SUBJECT: Approval Replacement System Variance Request, Belanger property, Rt 3 - North Belfast Avenue, Augusta

**SITE EVALUATOR STATEMENT
BELANGER REPLACEMENT VARIANCE REQUEST-11/22/98**

SUBSURFACE WASTEWATER DISPOSAL SYSTEM APPLICATION

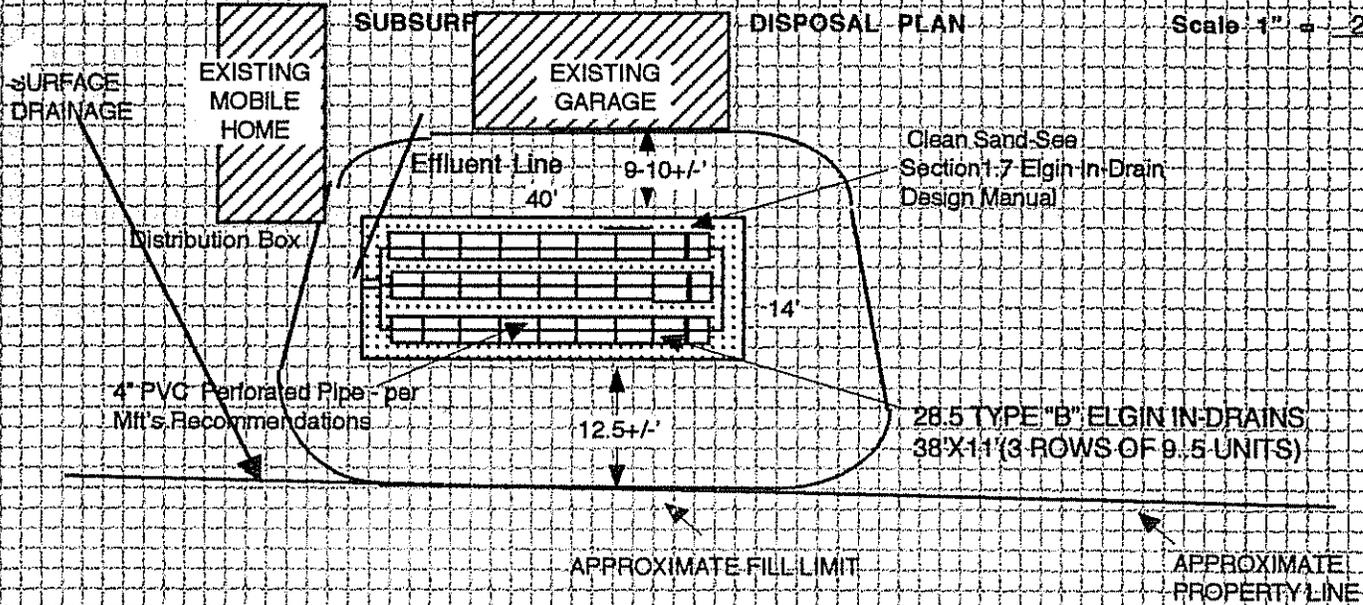
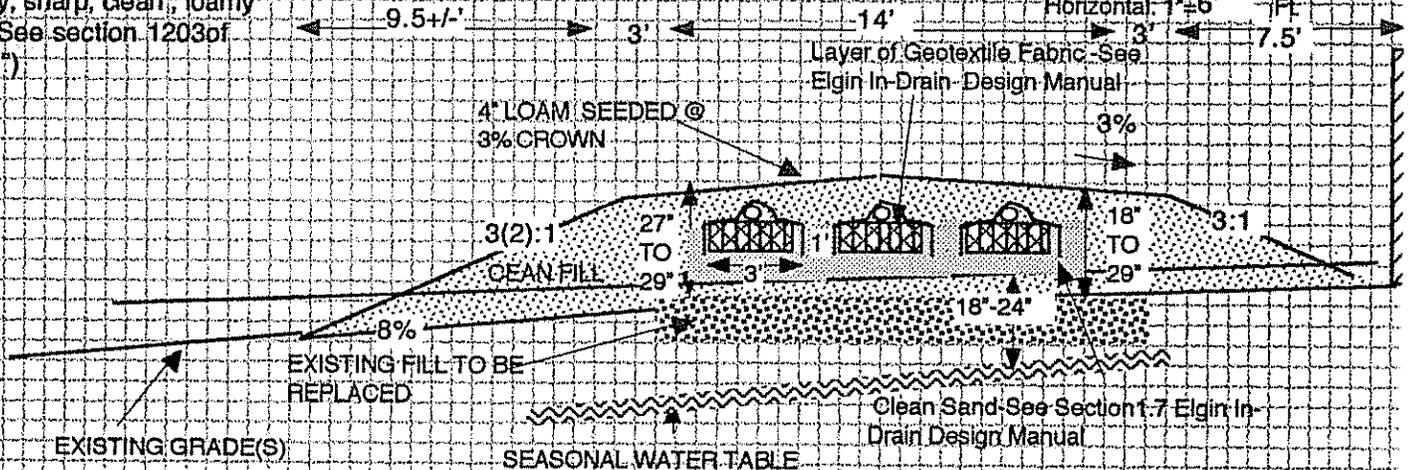
The Division has reviewed a replacement system variance request for the subject property. The state variances requested are to allow the installation of a subsurface wastewater disposal system in soils with zero inches to the ground water table and a reduced fill extension grade to 2:1 as needed. Due to the site constraints, the system is to be installed in the area of the existing system. The system designed by John Archard, SE, dated 11-22-98, is found to be in compliance with the Maine Subsurface Wastewater Disposal Rules.

1. Fill extension Grade - to 3:1 *REDUCE TO 2:1 AS NEEDED*

Because there is limited space it is necessary to reduce fill slopes in some areas to less than 3:1. It is this evaluators opinion that this is the most practical alternative available to replace the existing malfunction.

We approve the variance request with the following requirements:

1. A permit for system installation is to be obtained from the Local Plumbing Inspector in advance of the start of system construction.
2. The system is to be installed in accordance with the submitted and approved system design. Should alterations to the design be required at the time of construction, the system designer is to be notified prior to making any changes.
3. The system designer is to be retained to oversee the removal of the old system and fill material and the placement of the new fill material.
4. The variance approval does not relieve the property owner from compliance with all other state and local requirements regarding the permitting, installing, and utilizing of the septic system.
